KN PLANNING PTY LIMITED

Ref:KN693/02

**Re: State Significant Development Application-82900461 for demolition of four (4) dwellings and erection of 9-storey residential flat building and associated basement parking
11-19 Middle Harbour Road Lindfield
Submission of objection on behalf of 9 Middle Harbour Road Lindfield**

Figure 5: 1% AEP Flood Level Contours

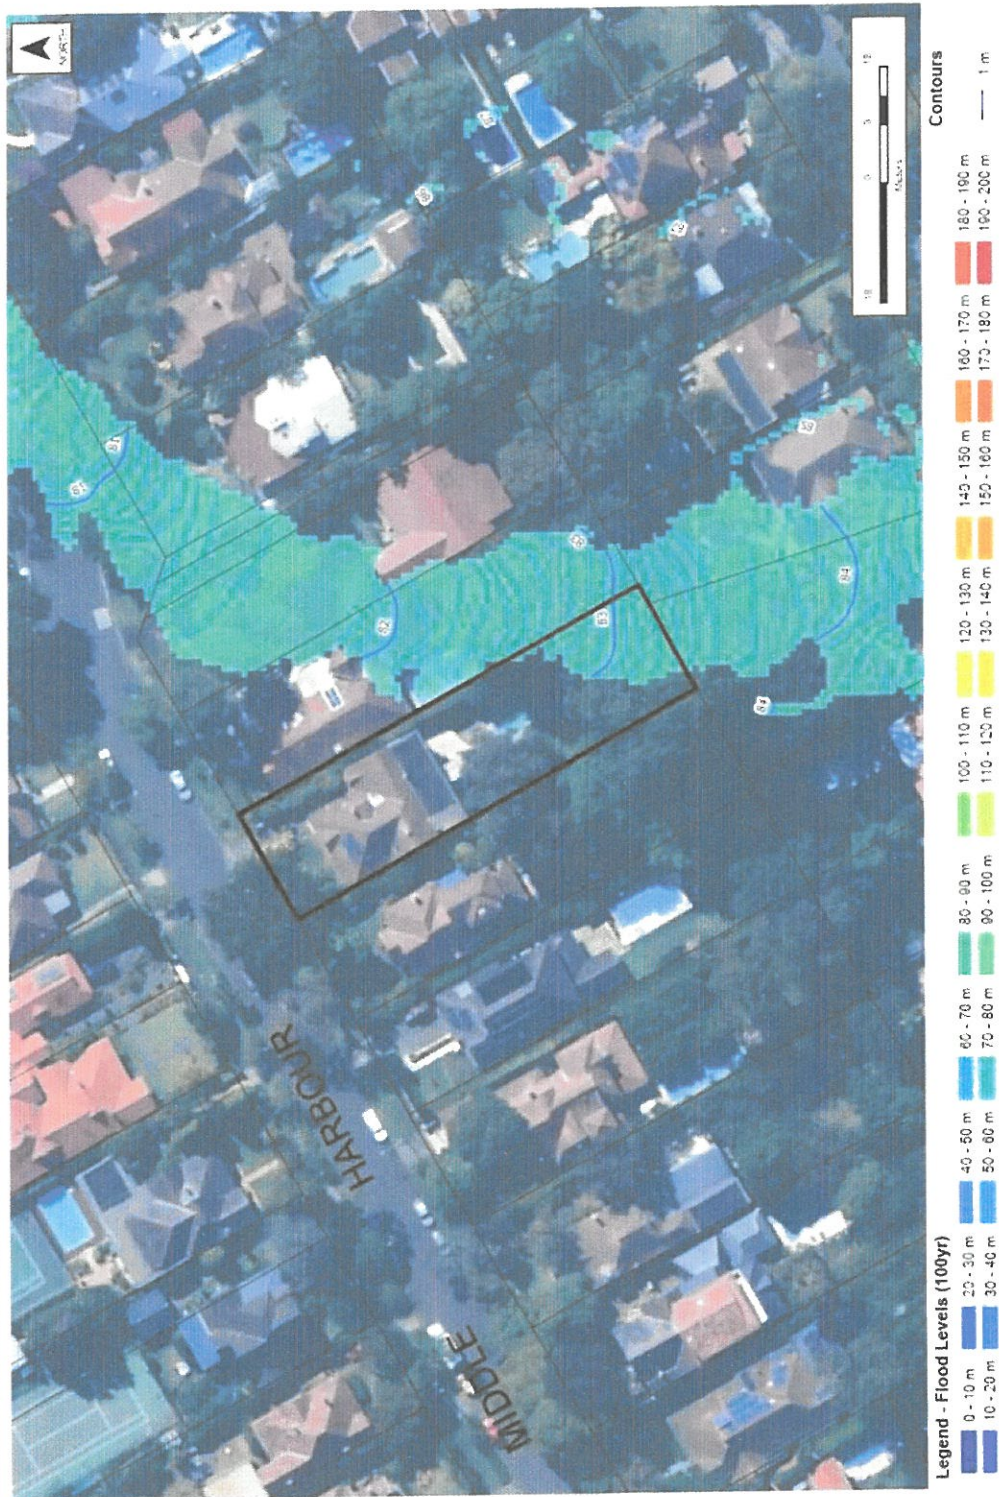
The Flood Impact Risk Assessment Report prepared by SCG includes a map of the 1% AEP Flood Level Contours on 19 Middle Harbour Road which indicates an triangular area of the south-eastern (rear) corner of the site (No.19) 17 metres (along rear boundary) by 22 metres (along the side boundary with 21 Middle Harbour Road) will have a flood level above RL83 metres, as evidenced at *Figure 5*.

The architectural drawings lodged with the application indicate the following development within the identified 1% overland flood extent demonstrated in *Figure 5* above, namely:

- *Lower ground floor apartments (2)* – at RL82.00 these units likely impacted in 1% flood event with existing flood contour at RL83+ as indicated on *Figure 5* above. With the likelihood of the properties to the east -21-29 Middle Harbour Road being redeveloped in accordance with the TOD controls a building up to 22 metres in height setback 6 metres from the common side boundary will experience no solar access in the am period mid-winter. The “View from the Sun” projections do not indicate a development form likely on lands east of the subject site and are of little value in assessment compliance terms.

Figure 8: Drawing DA202/A -South Elevation

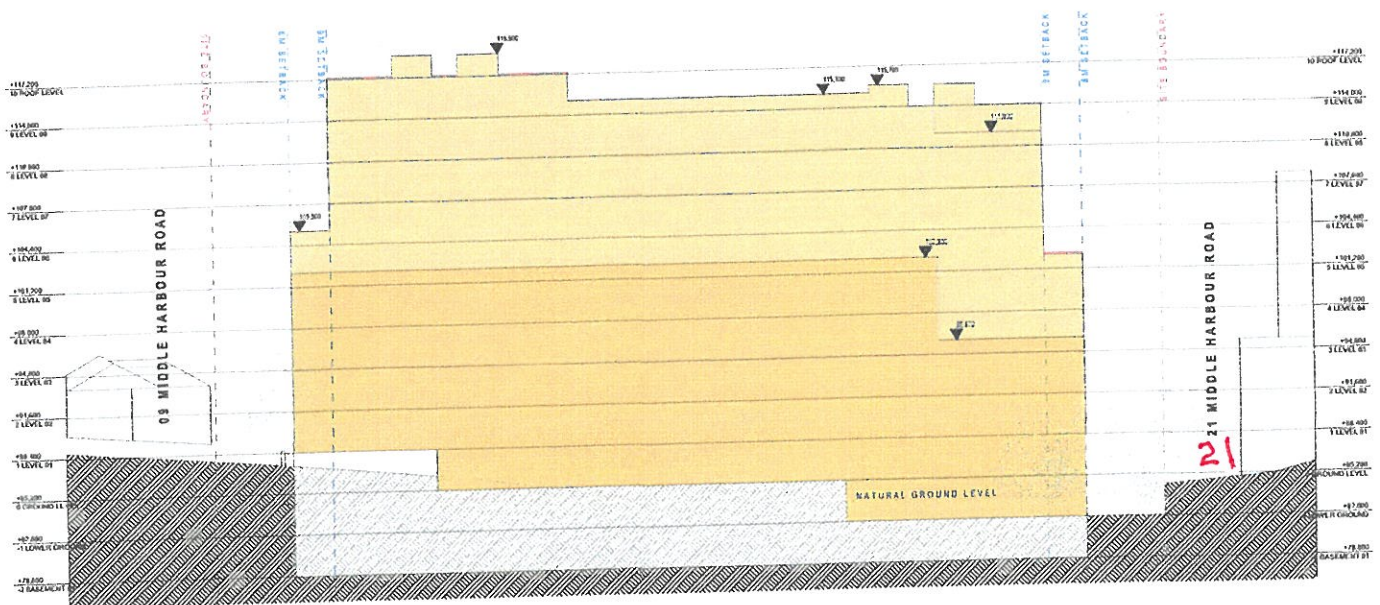
- Drawing DA301/A (*Figure 7*) shows the Lower Ground floor level car parking and two (2) affordable units in the rear south-eastern corner of the building within the 1% overland flood path at RL82.00 setback 5-6 metres from side boundary with No.21 and 6 metres from the rear boundary;
- Drawing DA202/A -South Elevation (*Figure 8*) indicates the extent of excavation at RL82.00 adjacent to the boundary with No.21 within the overland flood path at +RL83. Please note that the drawing does not accurately indicate the extent of excavation for Basement 01 up to the side boundary to No.21.

Figure 10: Extract from BDA report - Figure 4 watercourse

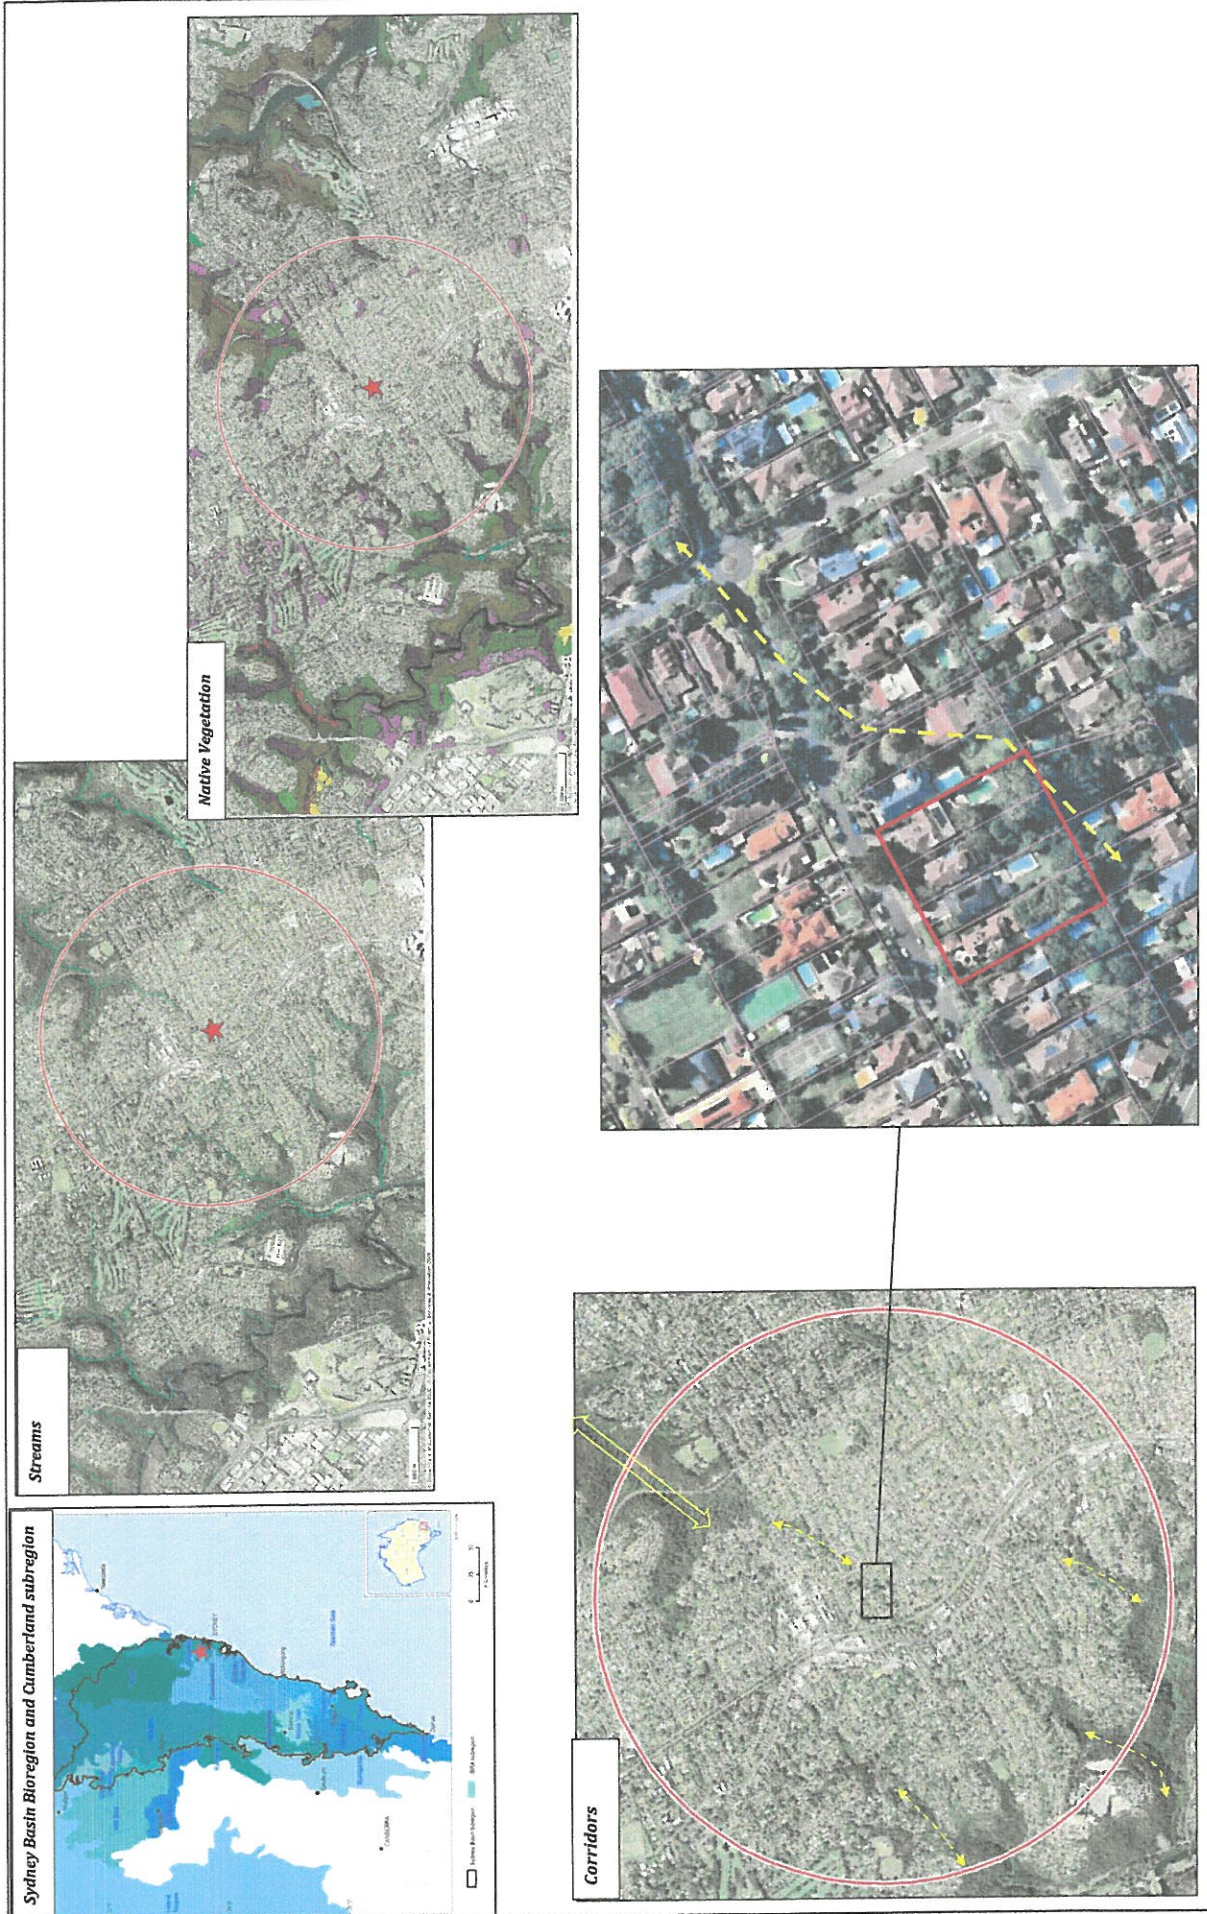
- The report does not reference the Terrestrial Biodiversity Map (*Figure 3*) under the KLEP;
- The report does not reference the Riparian Lands and Watercourses Map (*Figure 4*) under the KLEP. The report, at Section 2, only references a watercourse in the rear garden of 38 Middle Harbour Road 280 metres to the north-east of the subject site and Figure 4 (page 9) incorrectly plots the alignment of the category 3a watercourse external to the subject site (*Figure 10*). Section 5 of the report states that "*the development area does not have recognised drainage lines or other features associated with water bodies*". Such statement is not correct as evidenced by the Riparian Land and Watercourses Map and the Flood Impact Risk Assessment Report detailed above.

Figure 12: Drawing DA200/A – proposed building footprint

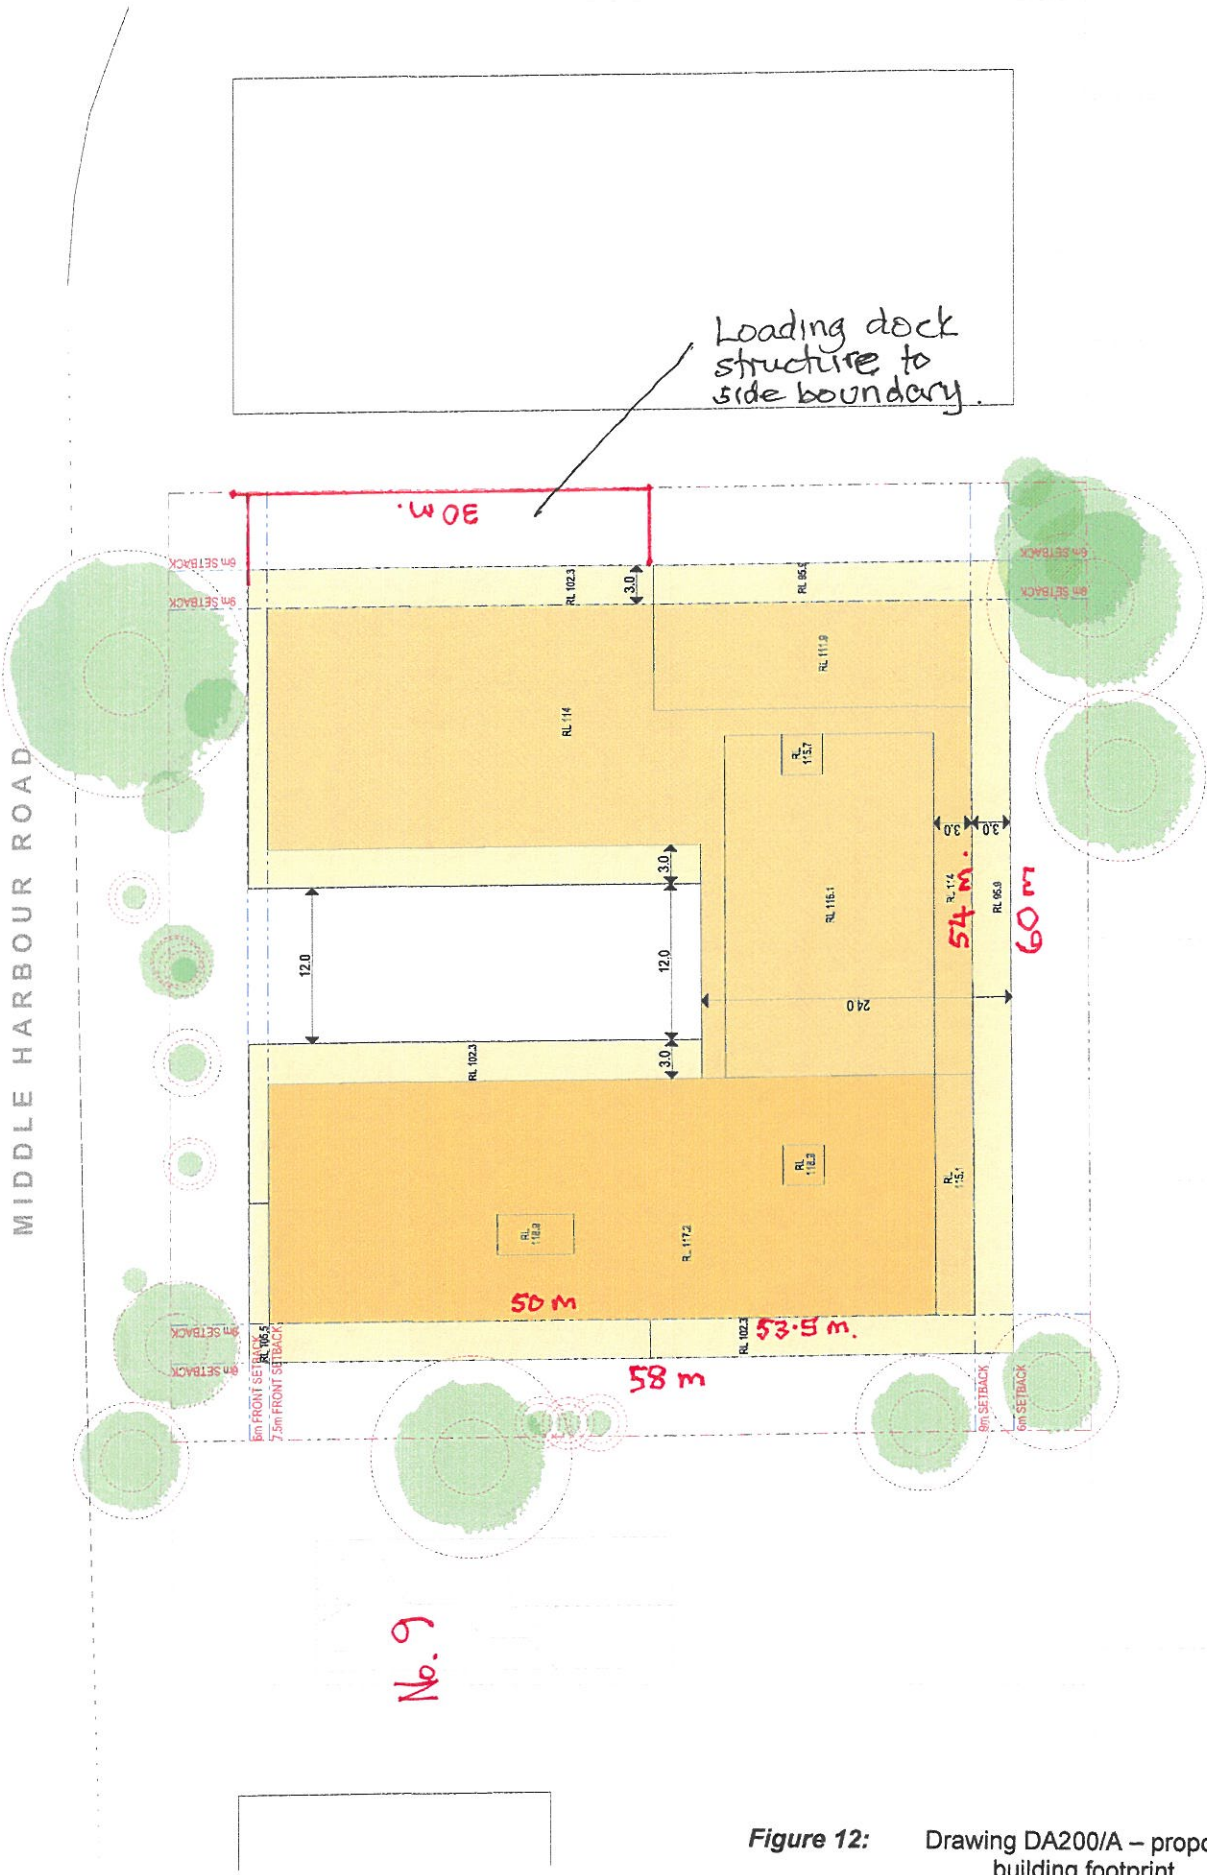
The proposed development will present as a visually dominating structure when viewed from adjoining properties to the west, south and east as detailed on the site plan at *Figure 12*, namely:

Figure 13: Drawing DA202/A – Western Elevation as viewed from 9 Middle Harbour Road

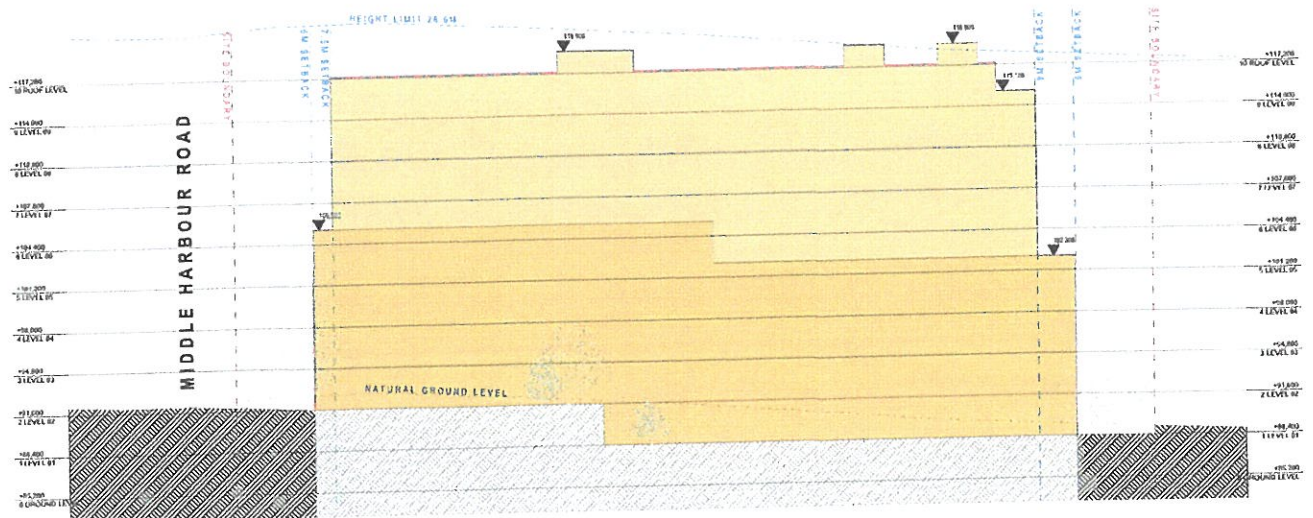
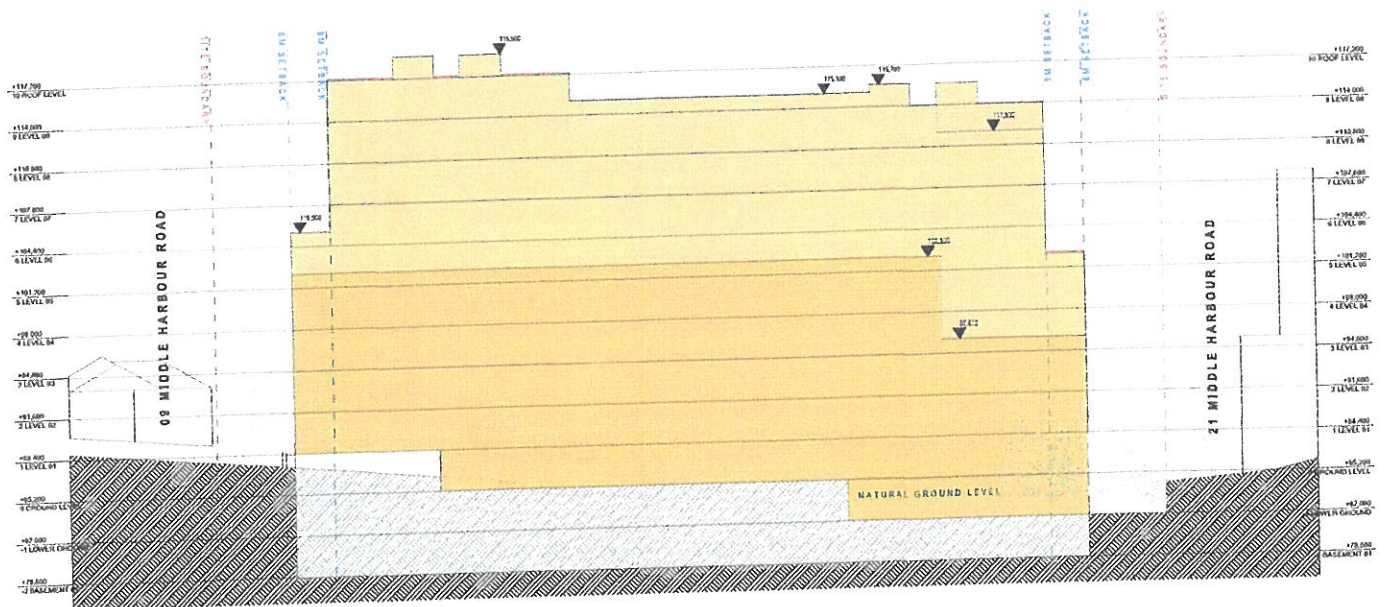
The proposal will present to the part 1/part 2-storey detached residence as a 9-storey building for a length of 58 metres, setback 6 metres from the common side boundary for 4-storeys and 9 metres for the remaining levels (*Figure 13*).

The proposal will present as a 10-storey building for a length of 60 metres setback 6 metres from the rear boundary for 5 levels and 9 metres thereafter (*Figure 14*). The properties on the northern side of Chelmsford Avenue fall within the TOD controls for Lindfield.

Figure 15: Drawing DA302/A Location of Loading Dock structure with zero setback to No. 21

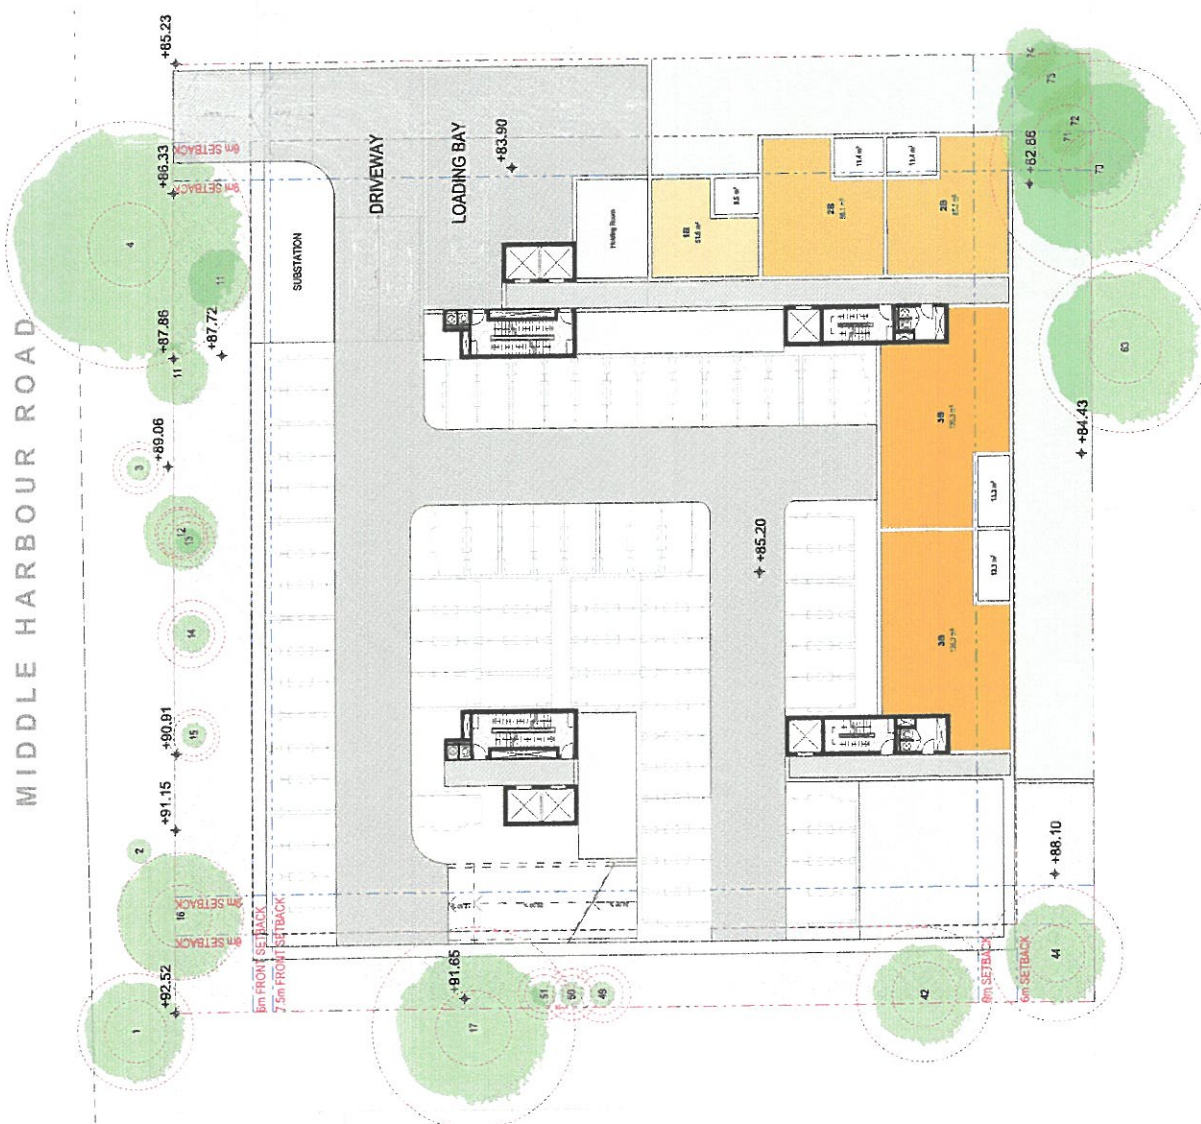
The proposal will have excavation for Basement 01 to the common side boundary with No.21 except for the 6-metre front and rear setbacks (*Figure 6*); a structure enclosing the access driveway to the basement parking and loading area is proposed to be built to the common side boundary with No. 21 to a height of 4.6 metres (RL88.40) for a length of 30 metres (*Figure 15*).

The zero setback to No.21 for the driveway access and loading dock structure to a height of RL88.40 – in the order of 4.6 metres high, setback 6 metres from the street alignment and the variable elevated parking podium to the street elevation will result in poor visual presentation of the building to the street exacerbated by the inadequate front setback and excessive bulk and scale.
